Fancy Fashion Sweaters Ltd. (Extension)

4 June 2023

Building-2 (Service Building): Six (G+5) storied building.

Jacquard Shed: Single storied shed.

Test report: Concrete crushing strength 3051 psi for column

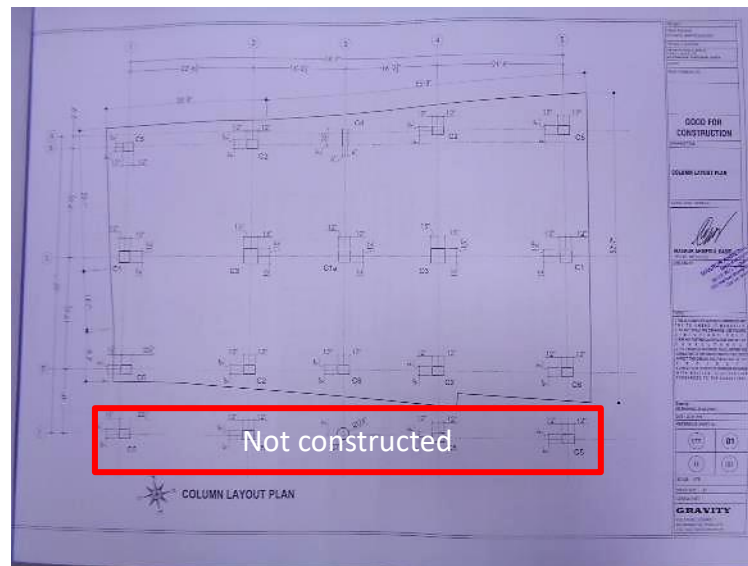
3 set of concrete test reports for column were available. As per BNBC, frequency of testing for the concrete cylinder doesn't satisfy. Also, one of the test result was well below the design strength. So, the building engineer is required to take concrete core from the existing building to confirm in-situ material strength. Prepare a complete set of design report based on as-built drawing and in-situ material strength of the structure.

Ground floor roof beam layout

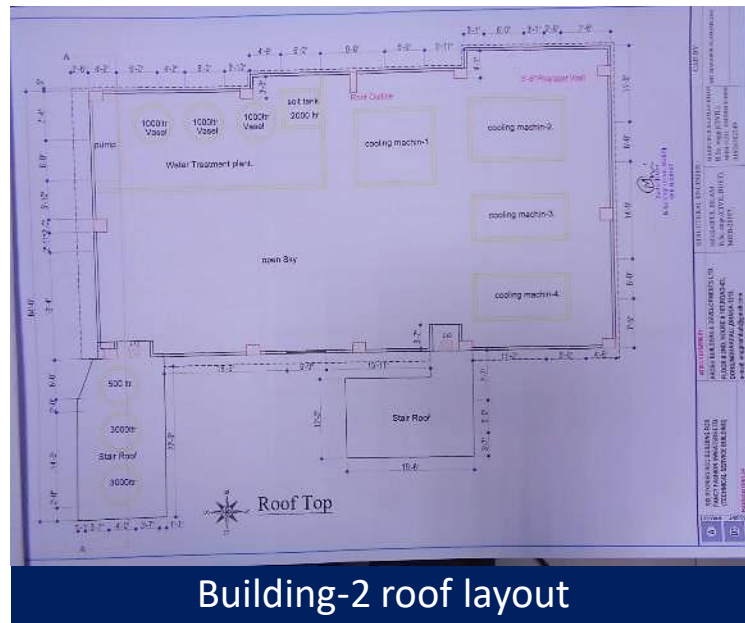
As-built drawings doesn't match with as-built condition. The building engineer is required to survey the structures and prepare accurate as-built drawings. Submit the drawing to the RSC for review.

Building-2 roof layout

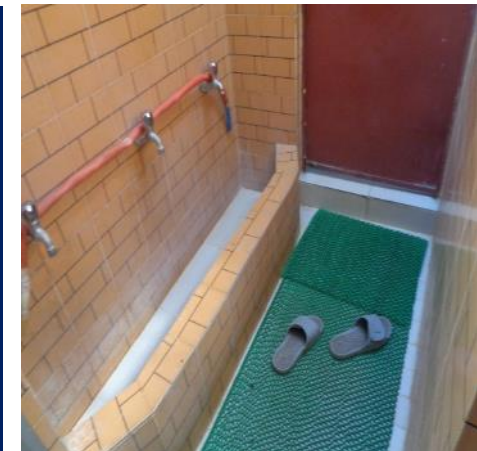
Two plastic water tanks and floor raises are not shown in the as-built drawings. The building engineer is required to survey the structures and prepare accurate as-built drawings.

Floor built-ups of toilet zone not shown in drawing.

Steel connecting bridge between Building-1 and Building-2

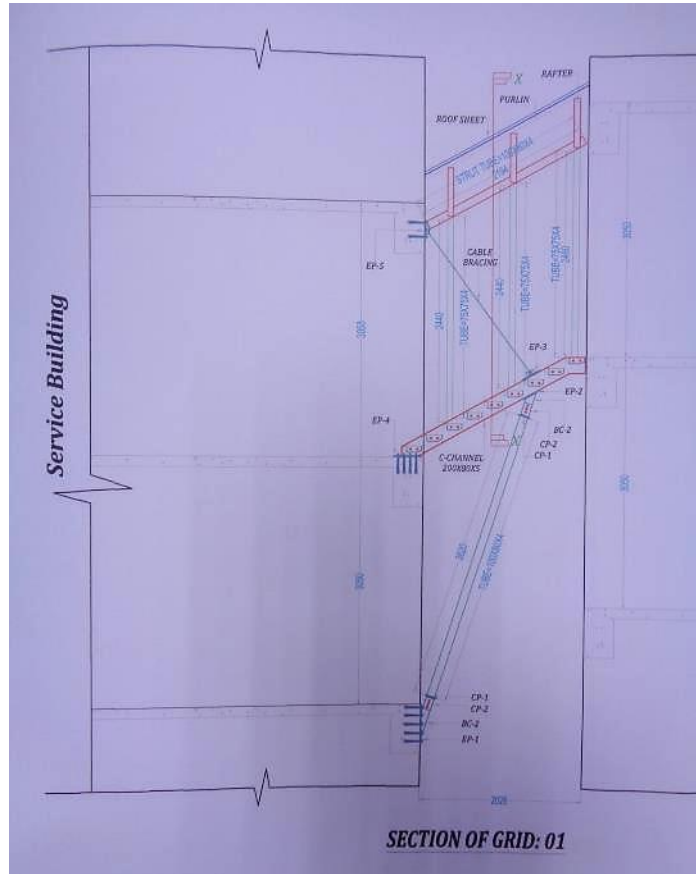
Only a set of drawing was available for the connecting bridge. The building engineer is required to check the adequacy of the steel connecting bridge and suggest necessary remedial actions if required.
